P24-01 REVISED The Shelly Company Demo and Reconstruction

Request: Revised Site Plan approval for the demolition of buildings and the construction of a

This letter is in regards to a change/revision to the previously approved Site Plan, Approval No. P24-01. During the development of the project, it was found that a taller building would be required to properly house the new proposed concrete batch plant.

II/19/24
SITE PLAN REVISION REVIEW RESUBMISSION

REFERENCE IMAGE SD-1 EXISTING BATCH PLANT TO BE REMOVED

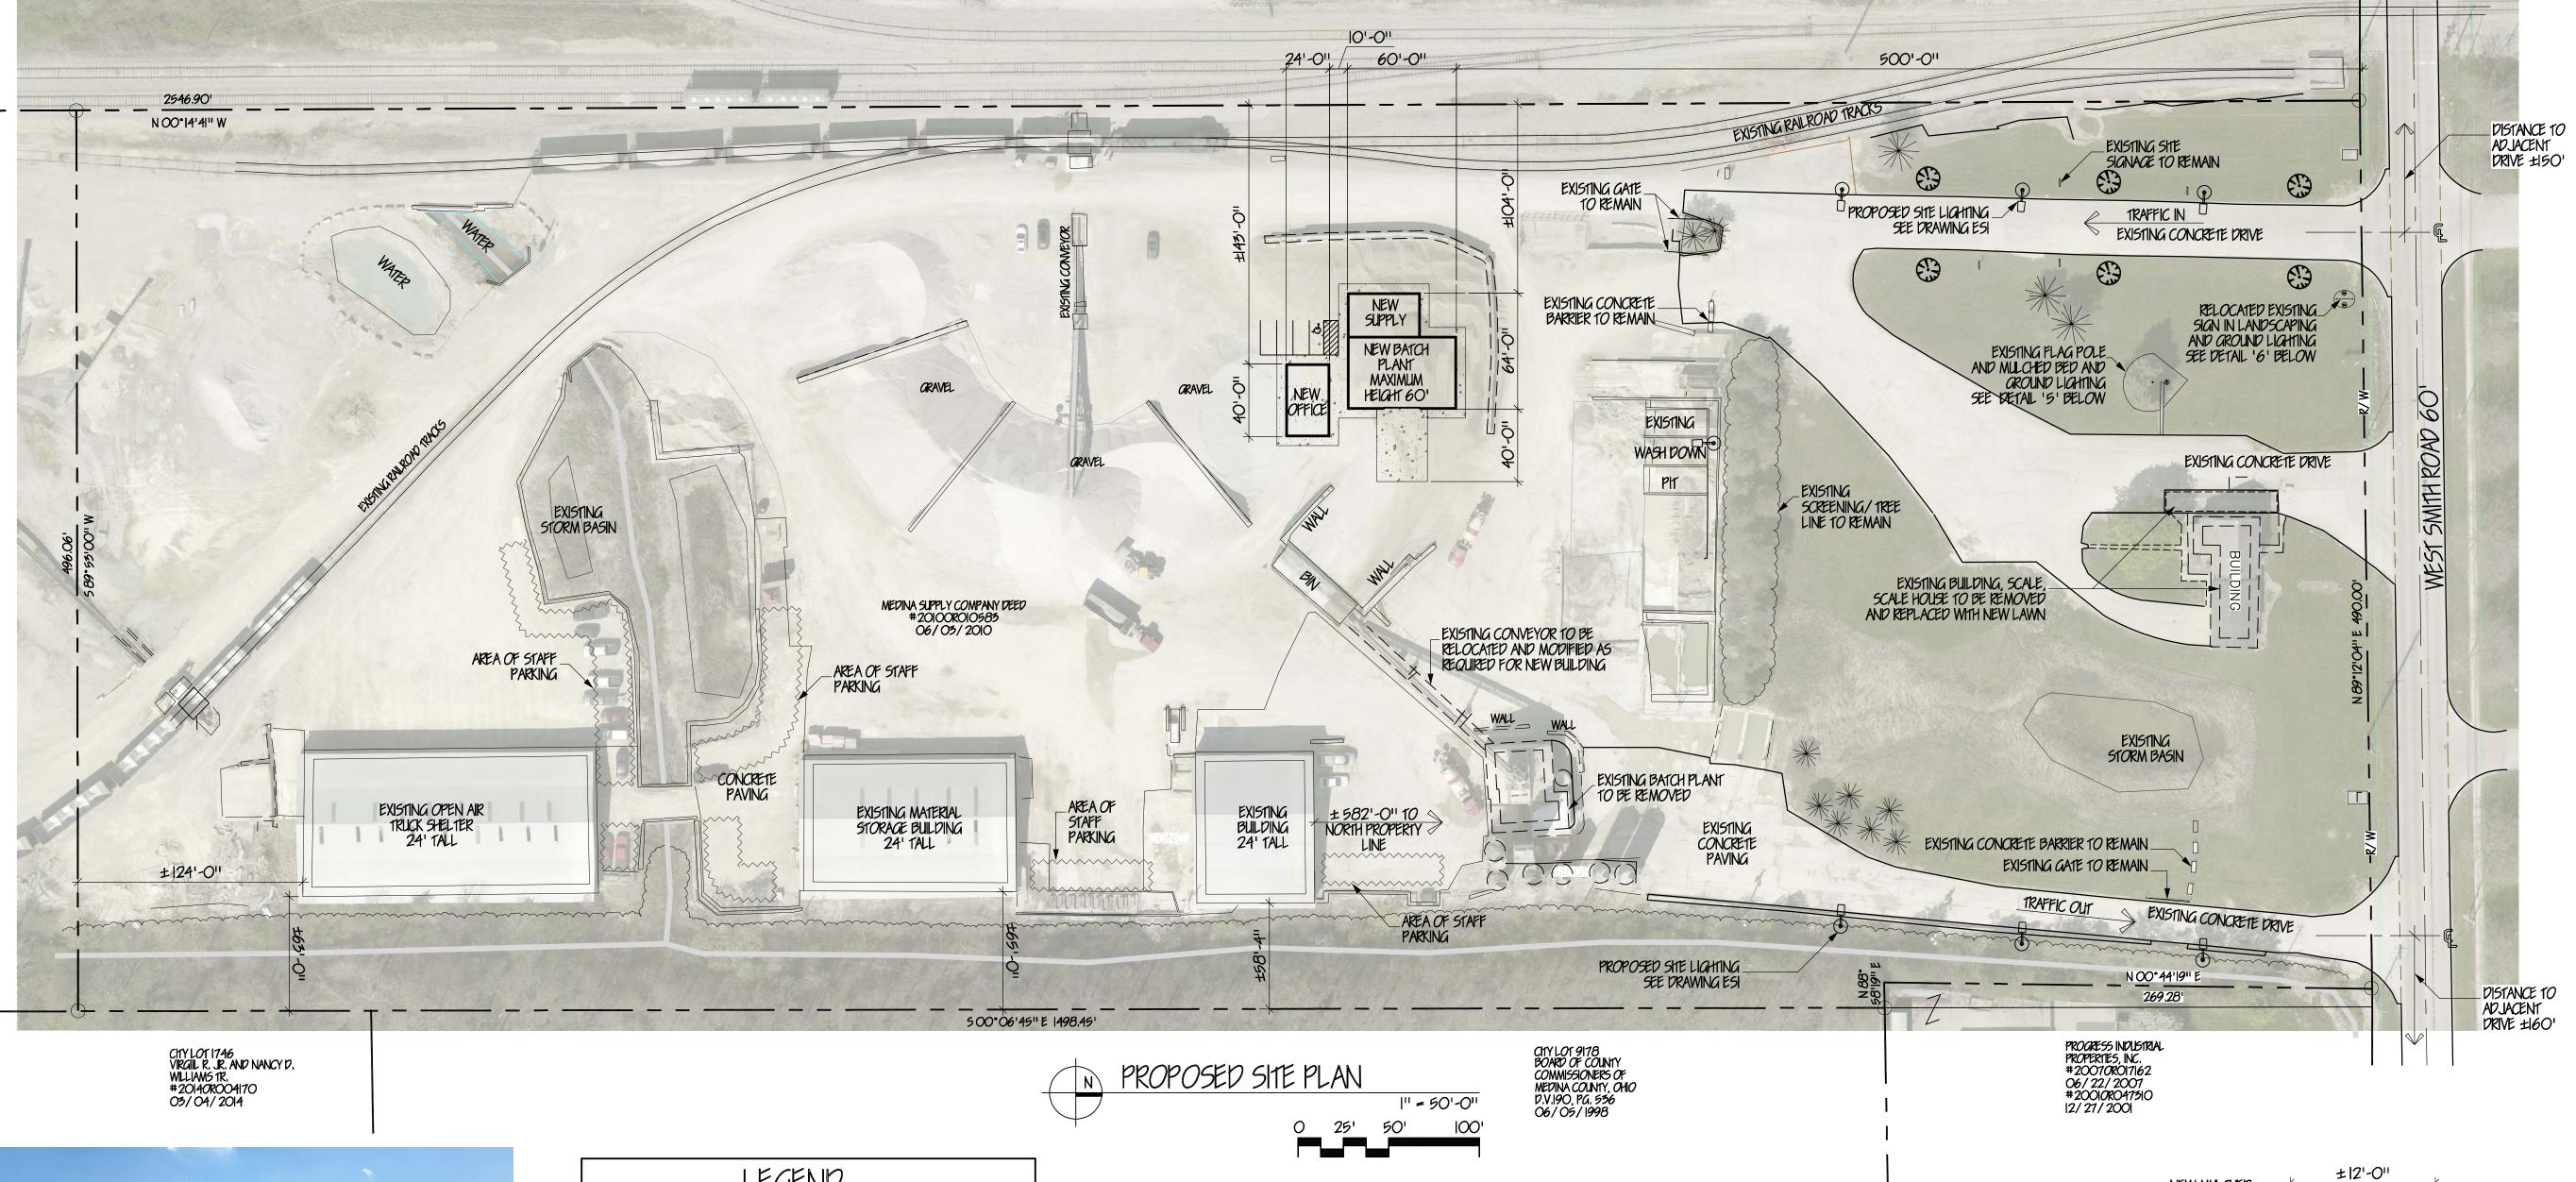
There is an additional change to the proposed building where the west storage area attached to the batch plant will no longer be required. This change will increase the building setback an additional 24' from the west property line. This will now place the proposed building 128' from the west property line.

Other additional site changes are first, the relocation of an existing silo currently located next to the east property line to the west side of the new batch plant. The second adjustment to the drawings, is that the existing scales located along the front of the property adjacent to West Smith Road will not be removed and will be left operational.

A-1 VIEW FROM WEST SMITH ROAD

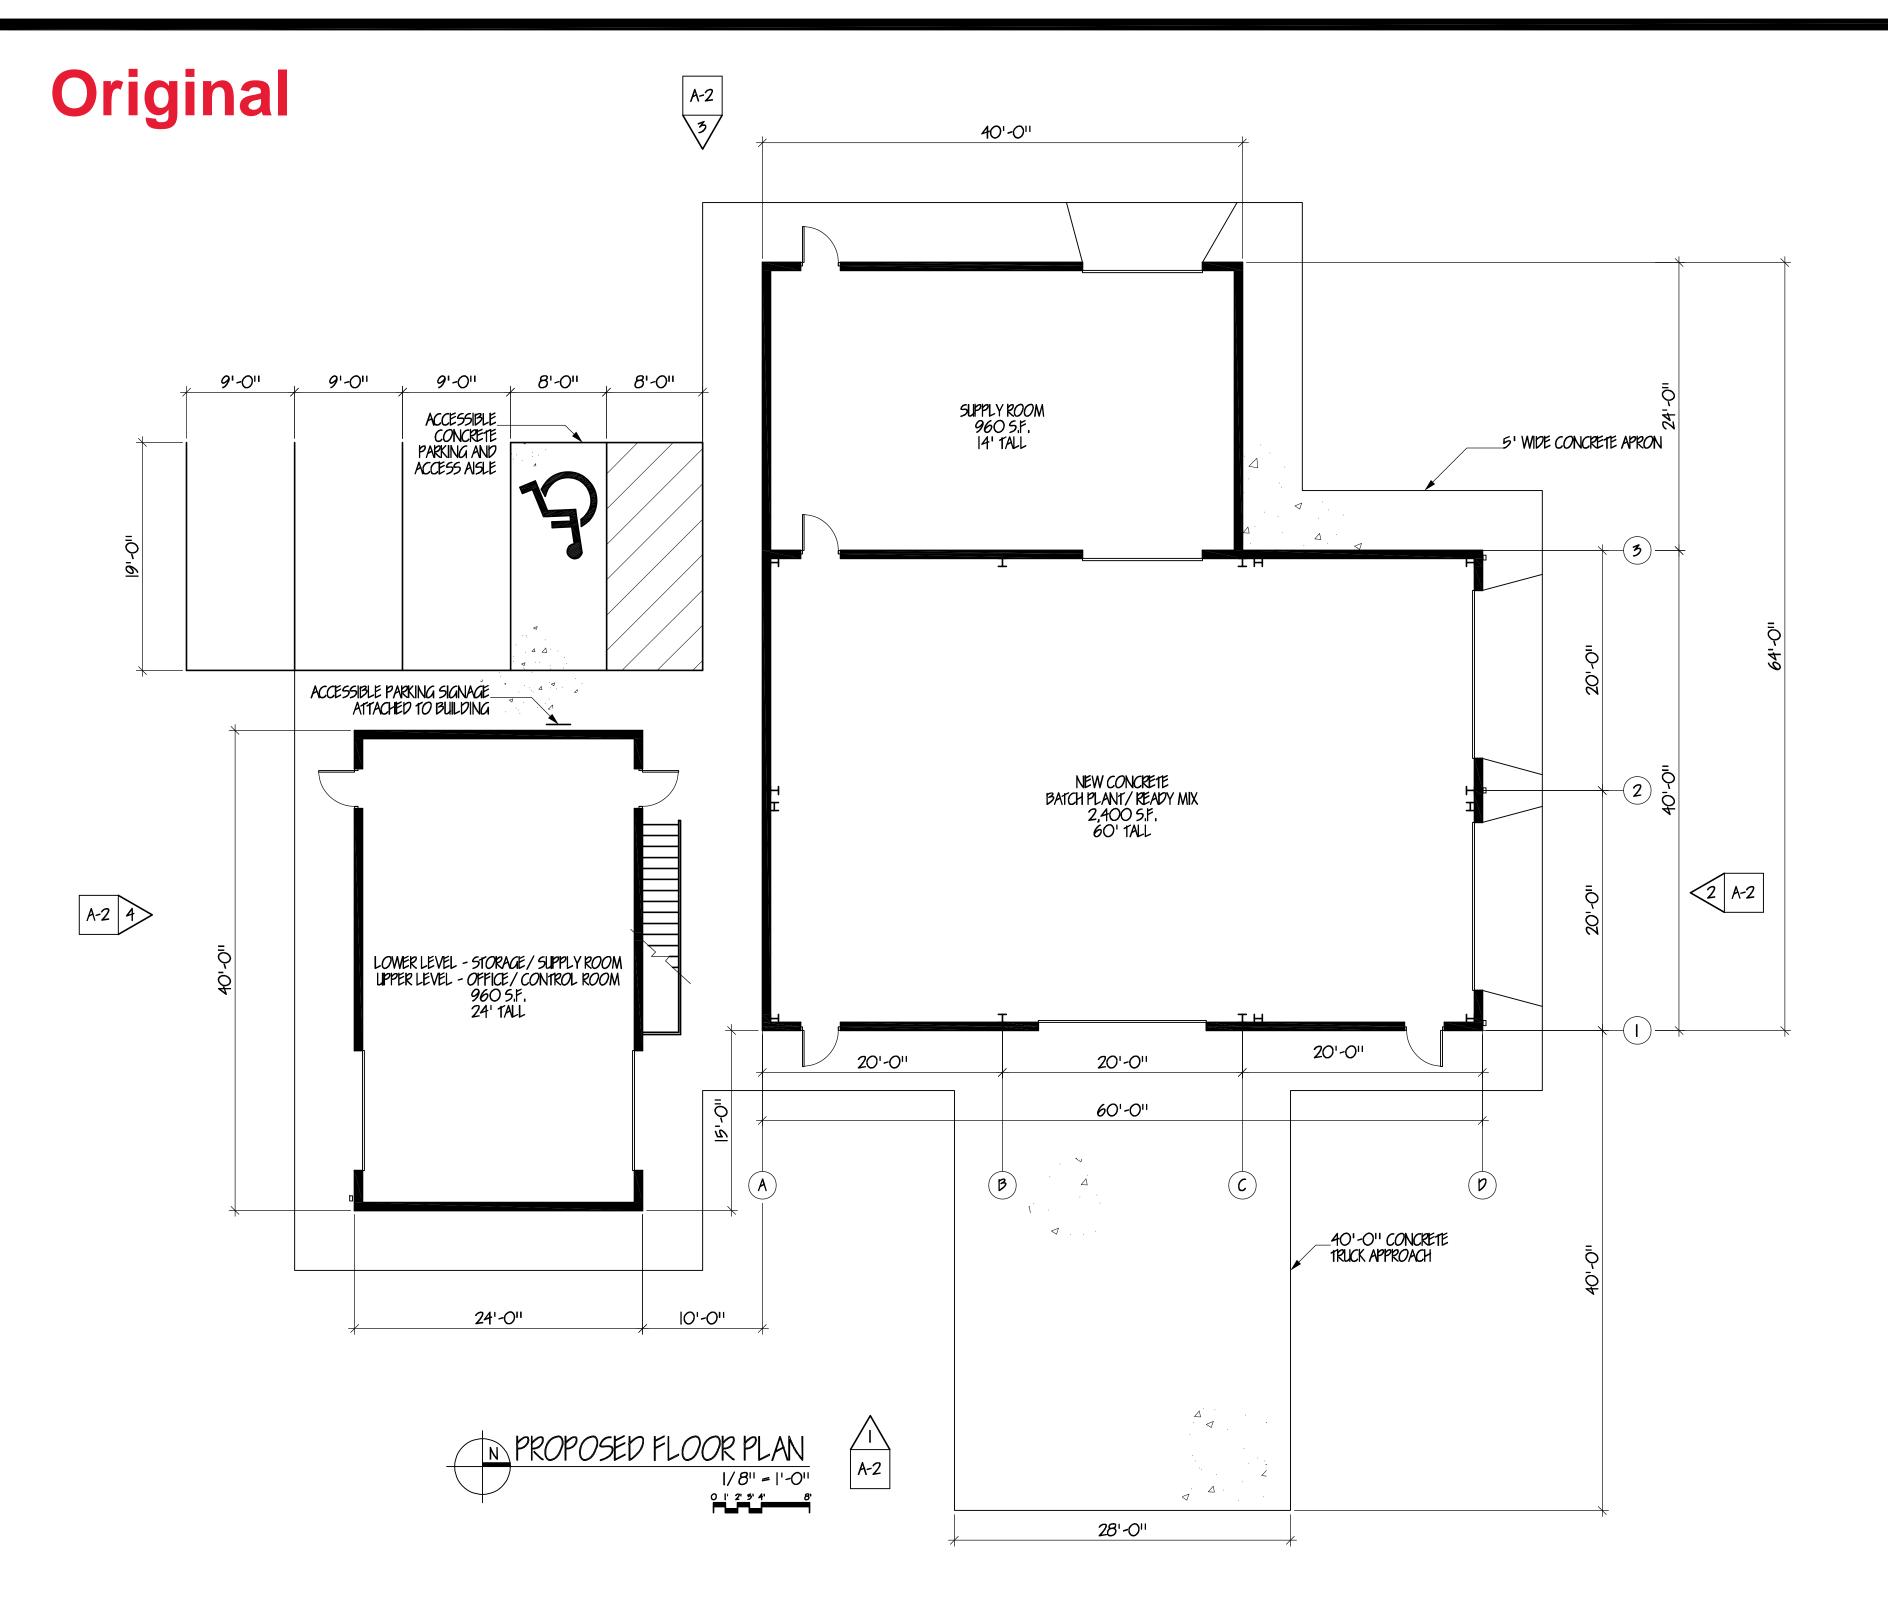
The proposed building height will go from the previously approved 60' in height, to a height of 78' to the top of the building. (78' is the highest point, top of roof)
